VILLAGE OF DOWNERS GROVE
Report for the Village Council Meeting
5/16/2017

SUBJECT:	SUBMITTED BY:
Stormwater and Floodplain Ordinance Variance 4710 Highland Avenue	Nan Newlon Director of Public Works

SUBJECT: 4710 Highland Avenue – Petition for Variance

Figure 1 – 4710 Highland / LPDA SJ79

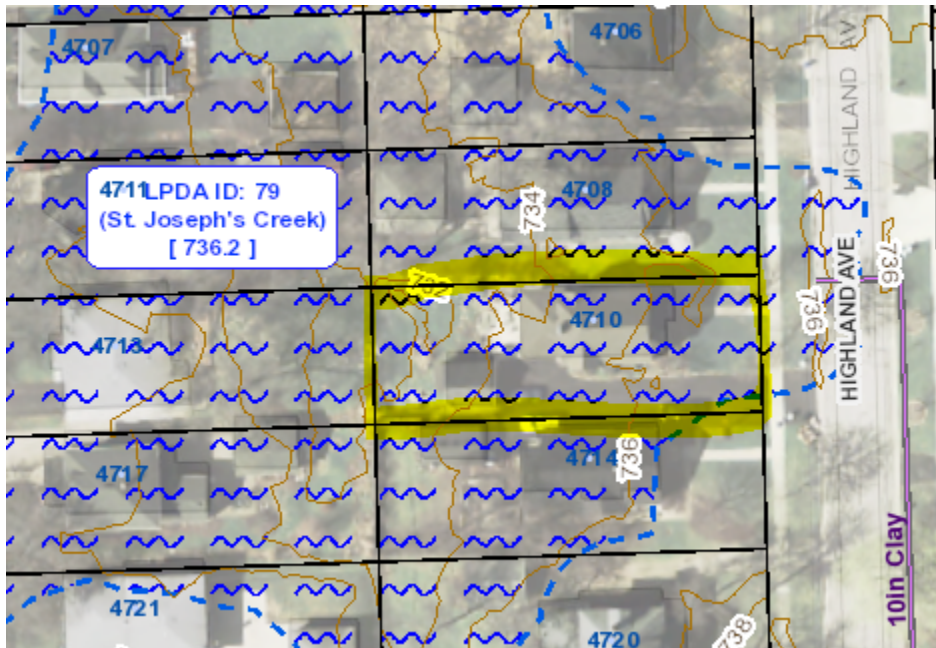
The homeowner applied for a permit to do the above work on September 15, 2016. Almost the entire lot, including the entire garage, is within LPDA SJ79, with a BFE of 736.2 (NAVD88), which would make the flood protection elevation (FPE) of 737.2 – see Figure 1. The existing driveway is shared with the neighbor to the south (4714 Highland Ave) – see Figure 2.

The homeowner's engineer submitted a site plan, which proposes a finished floor elevation of 734.4, which is 1.8 feet below the BFE. The plan proposes to move the garage to the north to meet the current 5' setback requirement. The elevation of the proposed garage is somewhat limited because of the shared driveway configuration. The plan provides compensatory storage for all fill within the LPDA (at a ratio of 1:1, as required by the Code). Flow through flood vents will be provided in accordance with FEMA TB-1 and Flood-Resistant Materials will be used per FEMA TB-2.

Staff recommends flood resistant materials be provided to an elevation of at least one foot above the BFE of 736.2, which would be a minimum of 737.2 or 2.8 feet above the proposed garage floor elevation of 734.4.
